<b>Title: Cavalon Magnetometer Re-Positioning</b>		<b>Compliance Category:</b>  <del>A – MANDATORY</del> <b>B – RECOMMENDED</b> <del>C – OPTIONAL</del>
<b>AG-SB-2020-04-B-EN</b>		
<b>Applicability</b>		
<b>Aircraft type &amp; model:</b>  Cavalon	<b>Affected Serial number(s):</b>  All Cavalon fitted with a Garmin G3X glass cockpit	
The maintenance manual to be referenced is this stated or subsequent issue.		As per AutoGyro website
This form is the response from AutoGyro GmbH either against a problem found in the product in service requiring a containment or rectification action, or as service information for aircraft modification incorporation. For help, contact AutoGyro on 49(0)5121 88056-00, or email <a href="mailto:airworthiness@auto-gyro.com">airworthiness@auto-gyro.com</a> .

**Reason and overview of the Service Bulletin (cause of problem if known)**

(Pic. 1)

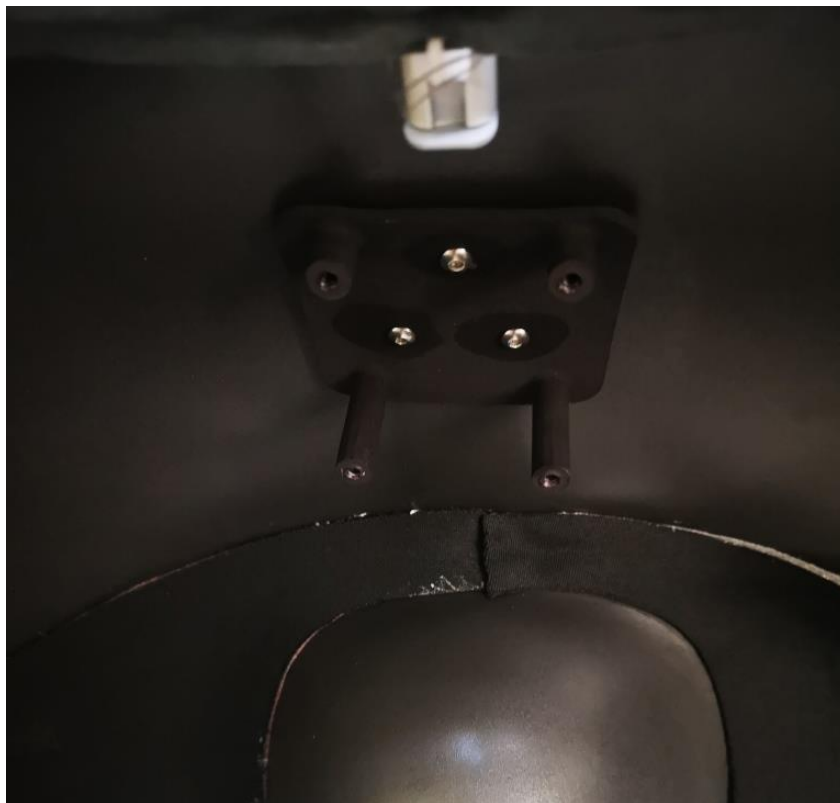
1. Ensure the wheel brakes are applied and the mag switches/ignition are switched in the "off" position.
2. Position the magnetometer bracket (47741) on the cabin roof approximately 75mm from upper edge of rear bulkhead foam to rear edge of mounting bracket and mark the 3 alu countersunk rivet nut hole positions on the cabin roof. The mount should be positioned exactly on the centerline of the aircraft for optimum sensor operation (Pic. 1)

3. Using a suitably adapted 6mm drill (Pic. 2), drill the 3 previously marked holes to M6.  
**NOTE: ensure that the outer fuselage is not contacted!**
4. Countersink the holes and assemble the countersunk rivet nuts in the cabin roof using M4 rivet nut pliers (Pic. 3).

(Pic. 3)

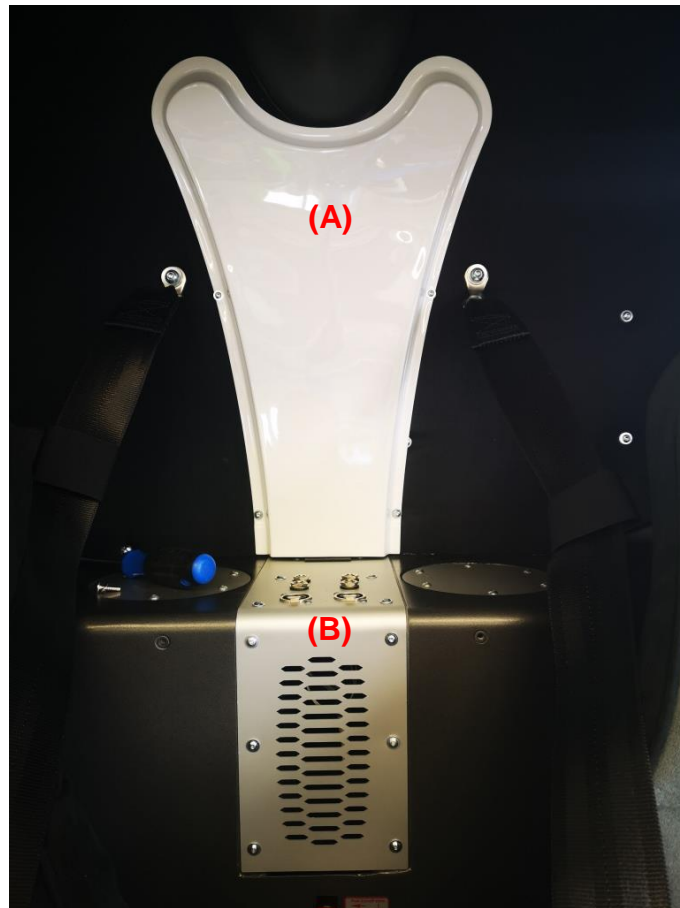
5. Assemble the bracket (47741) to the cabin roof using the 3 x Mx10 A2 screws and Loctite 221 red (30488) (Pic. 4).
6. Remove the throttle/brake center console iaw AMM Job Card 67-10-00 4-1.

(Pic. 5)

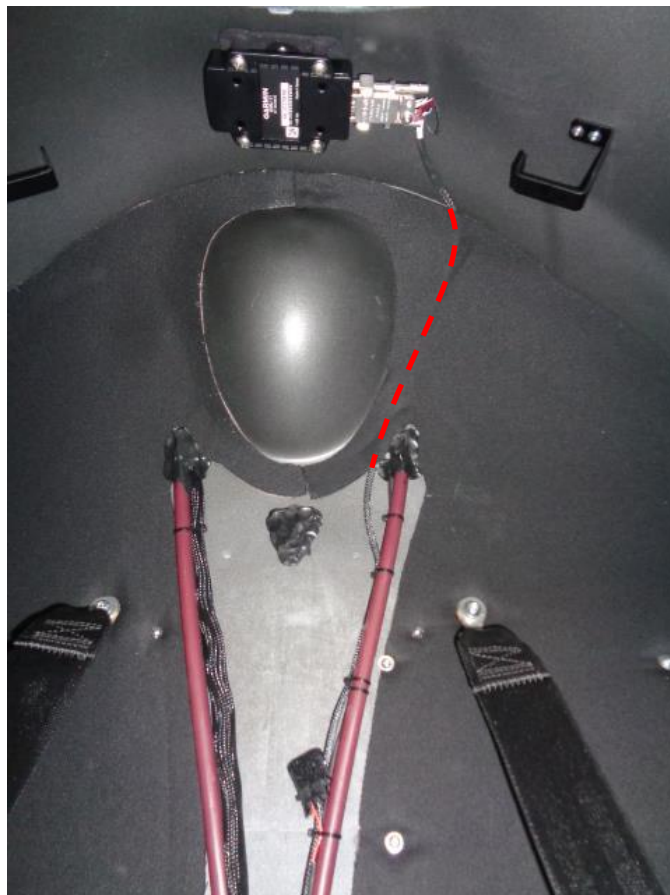
8. Remove the rear bulkhead PPC cover (Pic. 5, item A) & intercom panel (Pic. 5, item B).
9. Screw the 2 connecting nuts onto the Sub D plug from set 47742 (Pic. 6).

10. Connect the Sub D plug from the adapter cable to the existing magnetometer Sub D plug in the center channel (Pic. 7).
11. Route the cable along the left side of the center channel rearwards, between the tanks, behind the intercom console.

(Pic. 8)

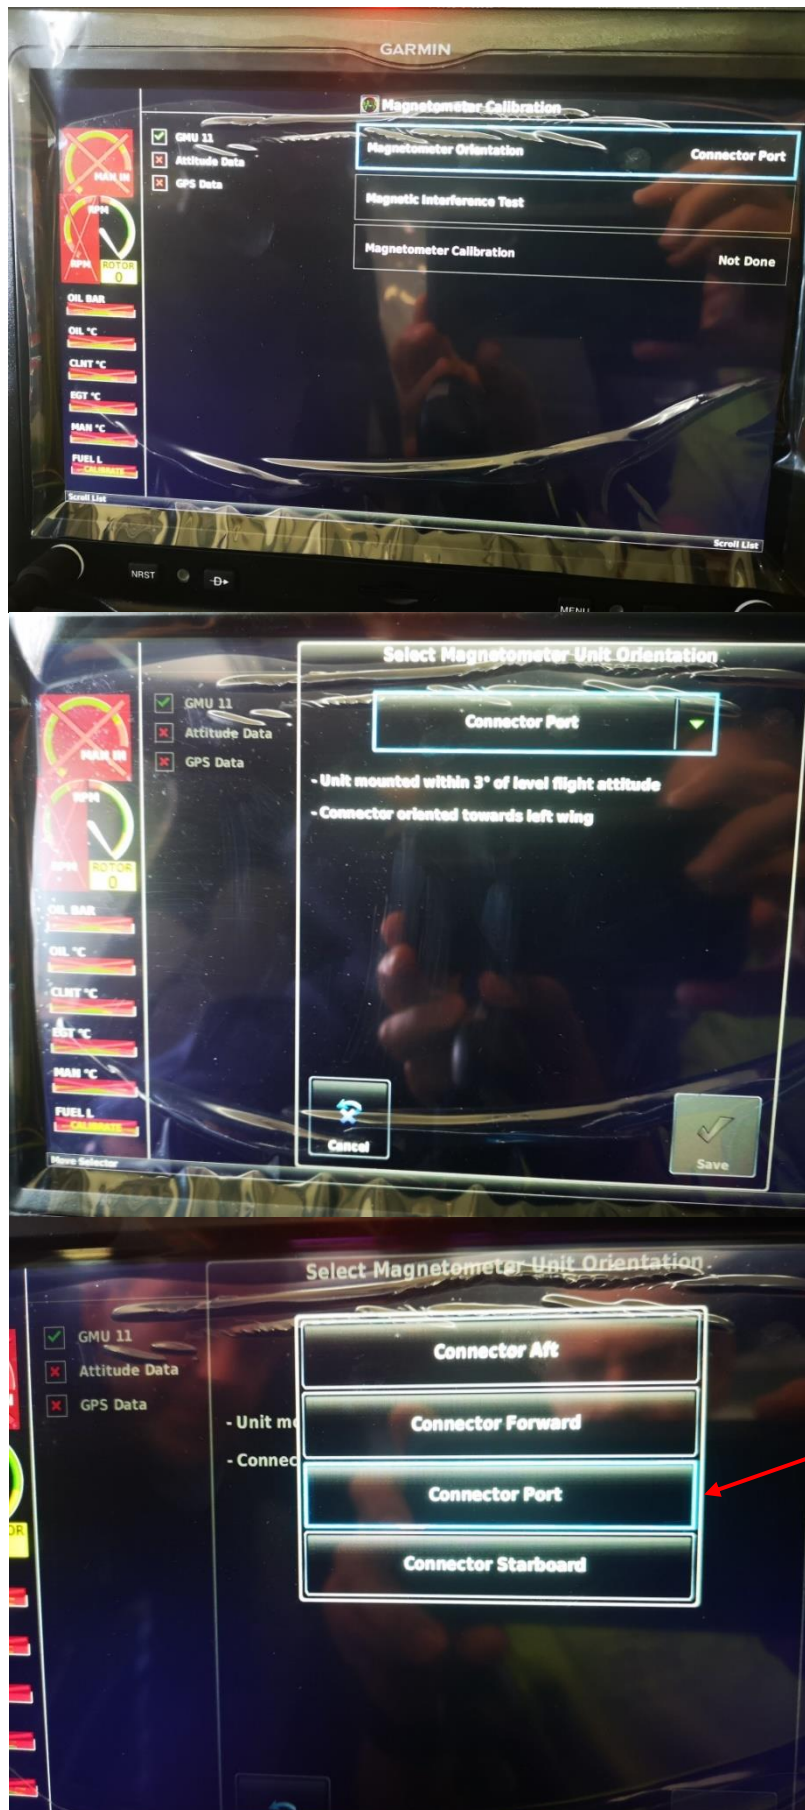
12. Remove enough of the upper left side of the rear bulkhead foam to route the cable behind it to the magnetometer.
13. Assemble the magnetometer to the mounting bracket (47741) using the 4 self-tapping stainless-steel 4.8x16 screws, and connect the Sub D plug from the extension cable (Pic. 8).

14. Route the cable behind the rear bulkhead foam, and re-adhere the foam to the bulkhead using contact glue Würth High-adhesion Spray Adhesive (31299) or similar (Pic. 9).
